**RELEASED FOR  
 FABRICATION / INSTALLATION**  
 PPPL Drafting:

Oak Ridge National Laboratory managed for the DEPARTMENT OF ENERGY under U.S. GOVERNMENT contract DE-AC05-00OR22725 UT-BATTELLE, LLC, Oak Ridge, Tennessee PROJECT NAME						
NATIONAL COMPACT STELLERATOR EXPERIMENT VACUUM VESSEL PERIOD INSPECTION AND LEAK CHECK ASSEMBLY						
VERSION NO.	PLANT	BLDG	FL	SHT OF	TYPE	CLASS
5	X-10	5700	3	2 19	A	U
RELEASE LEVEL		SE120-004			REV	
Fabrication					2

TYPICAL PORT 9A AND 9B SECTION PORT09-PORT09

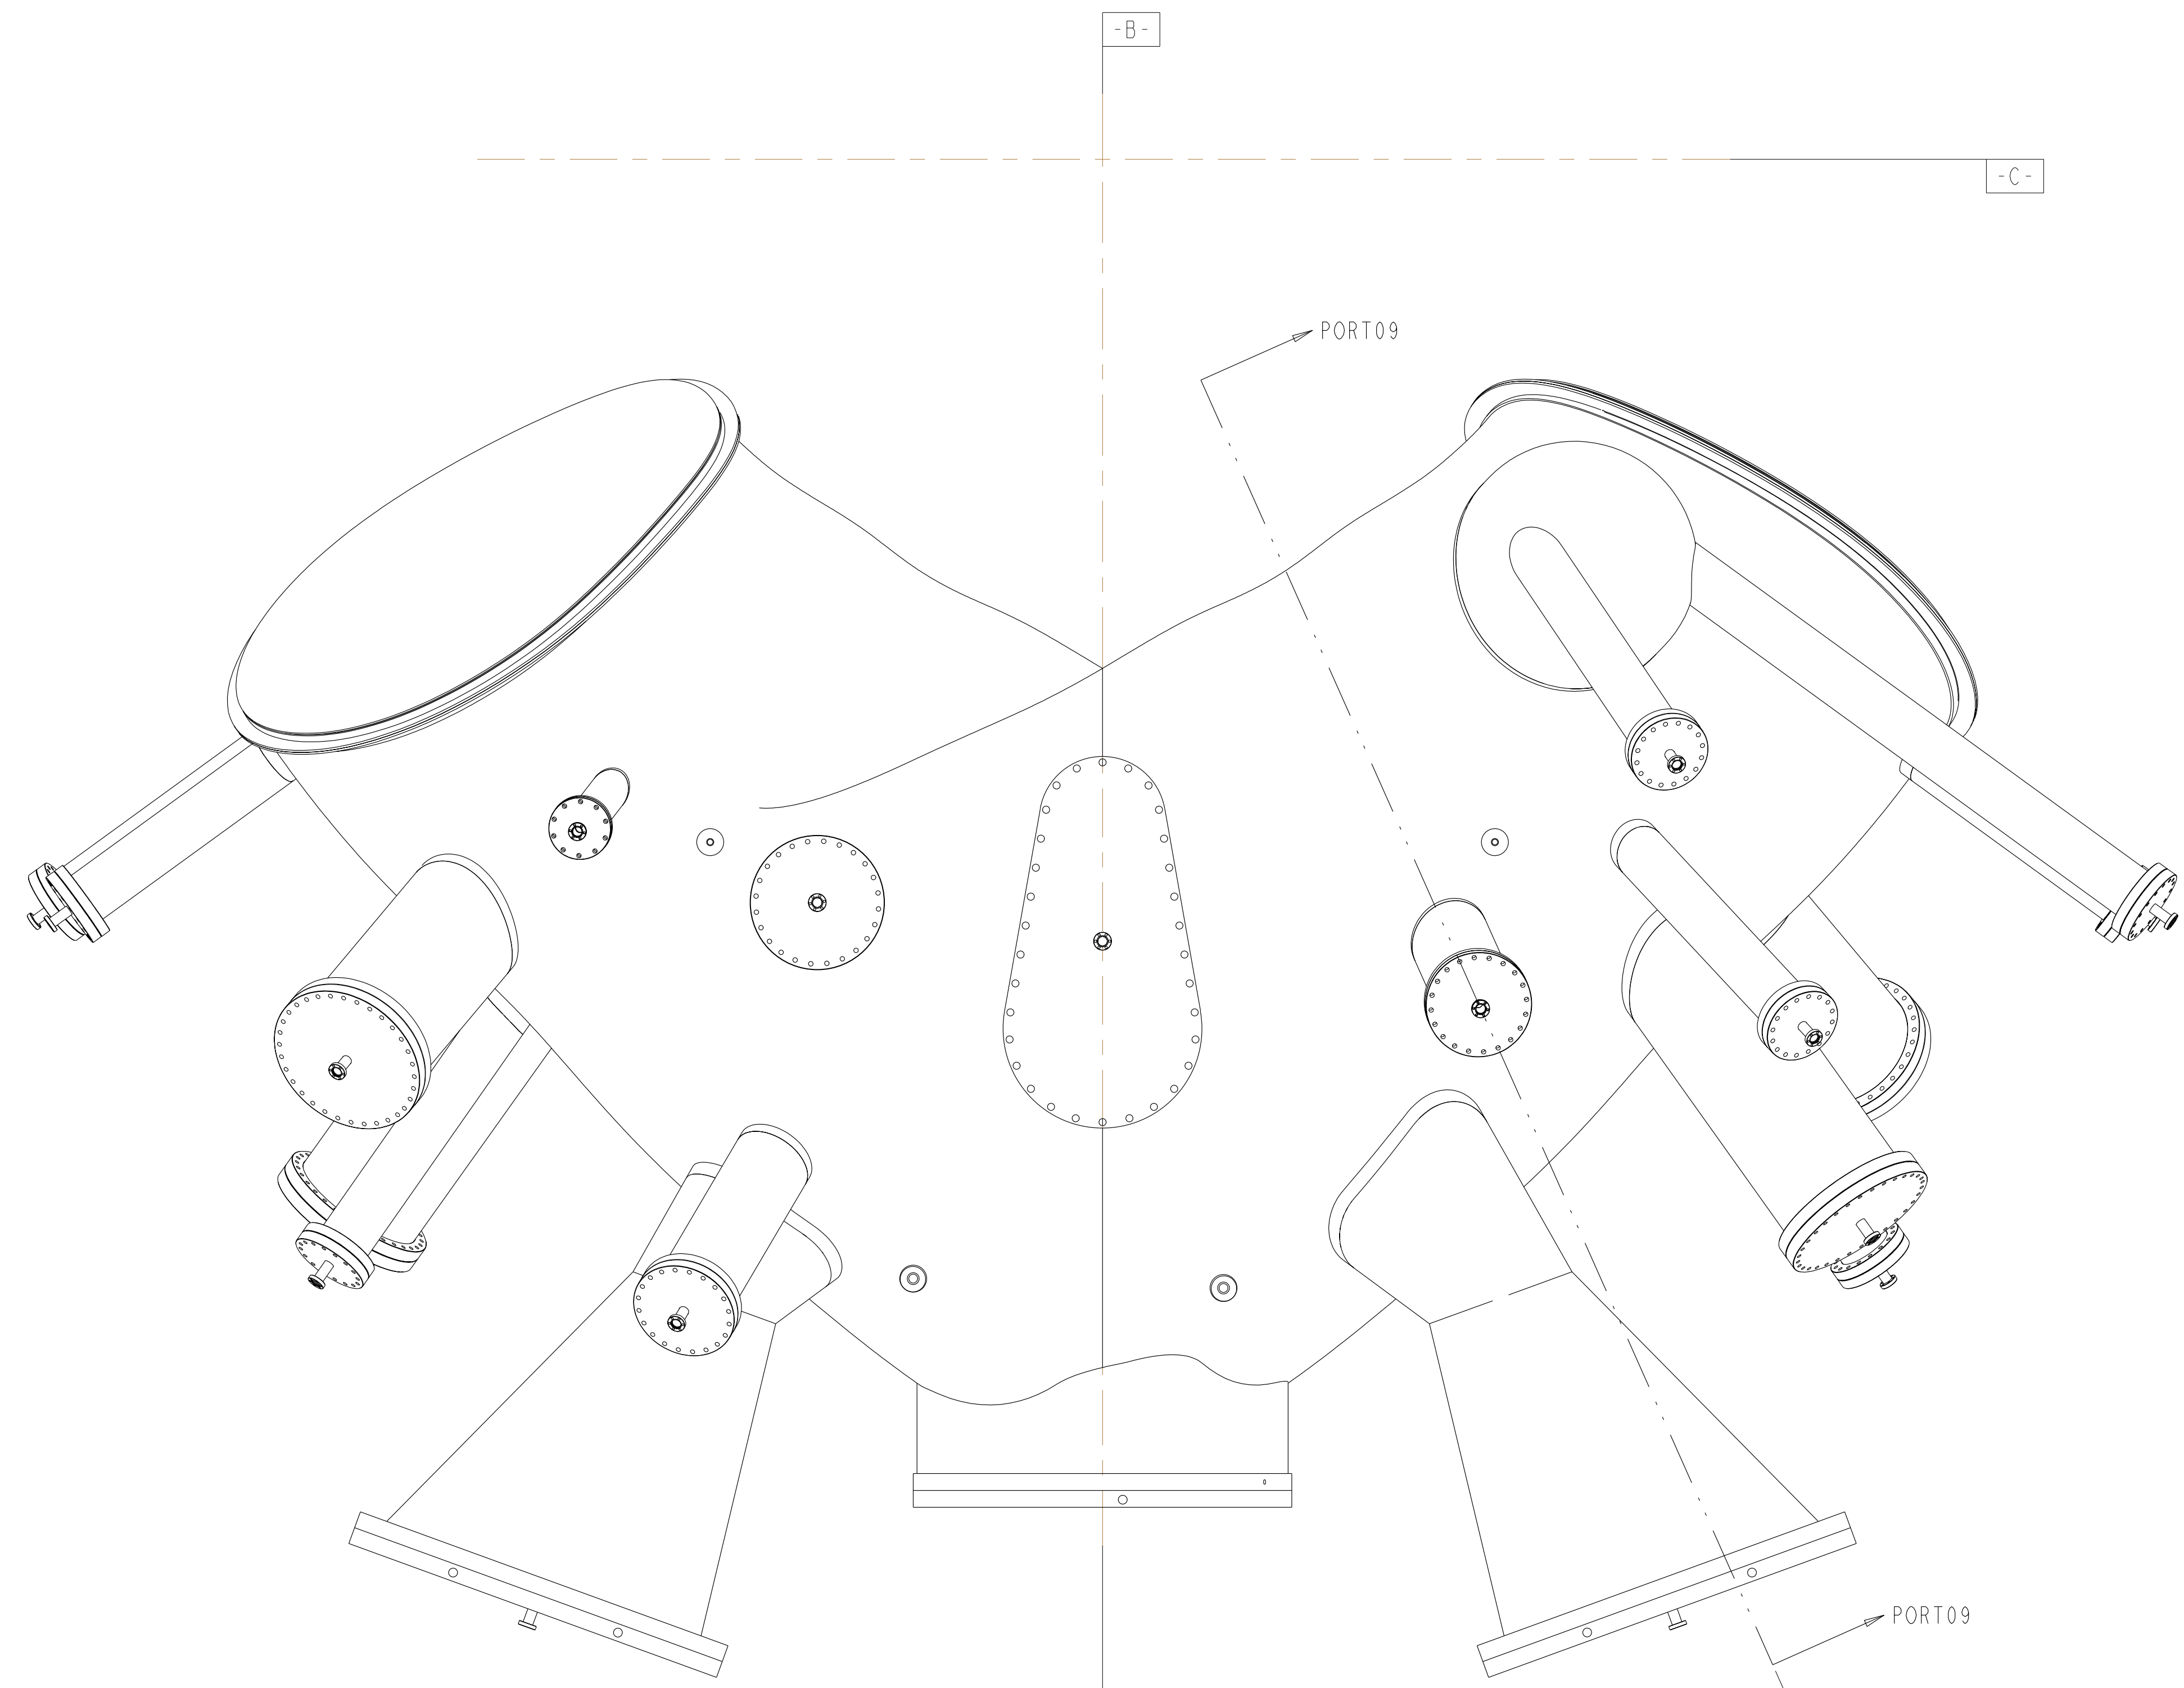
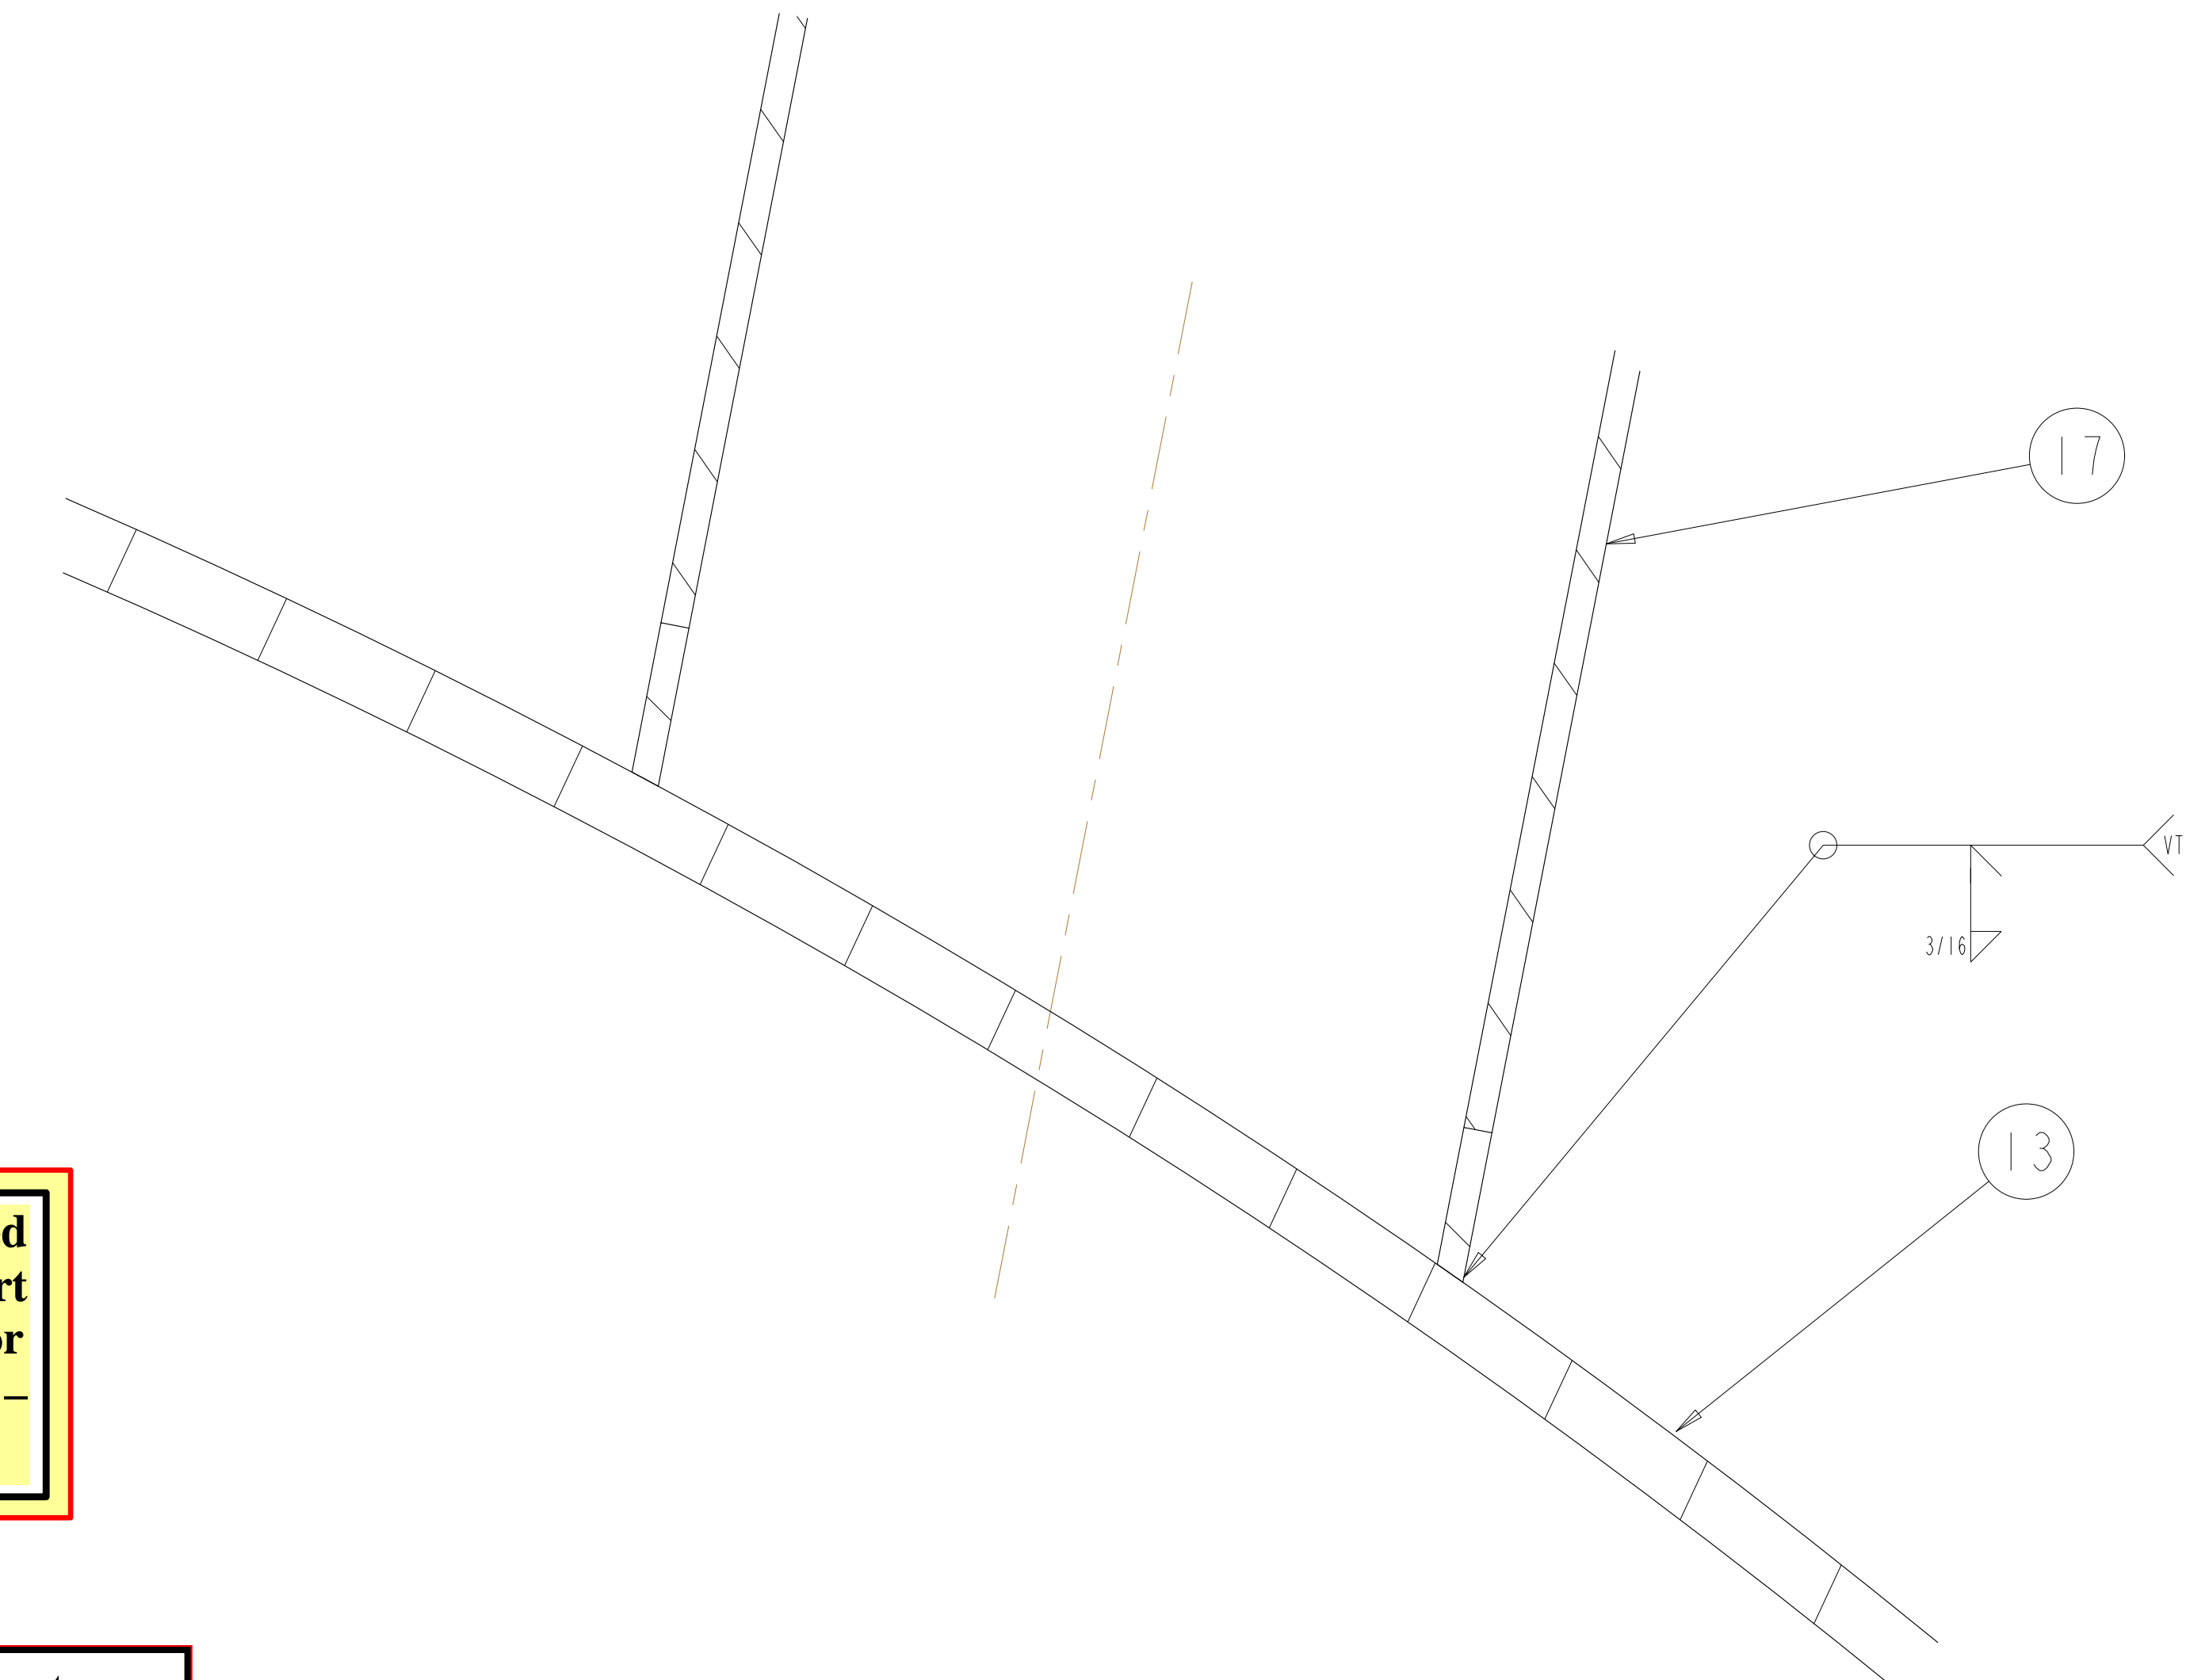
**Rev 2-e: ECN-5021 (RFD-12-017) approved alternate methods for welding the port extensions to the VVSA (See ECN-5021 for details). - Only applicable to VVSA #3 - VVSA #1 and #2 covered by NCR 19464.**

**ECN-5082.** Requirement originally included grooves to facilitate leak checking by vendor. However, vendor elected another means of leak checking and therefore the grooves are no longer required. Specifically, this ECN eliminated the leak checking groove on SE121-014 (Rev 1-c) and SE1221-091 (Rev 0-a). Additionally, this ECN added a missing weld symbol to SE121-004 (Sheets 4 through 19) for joining the port extensions to the vessel (Rev 2-d).  
 (See ECN-5082 for details)
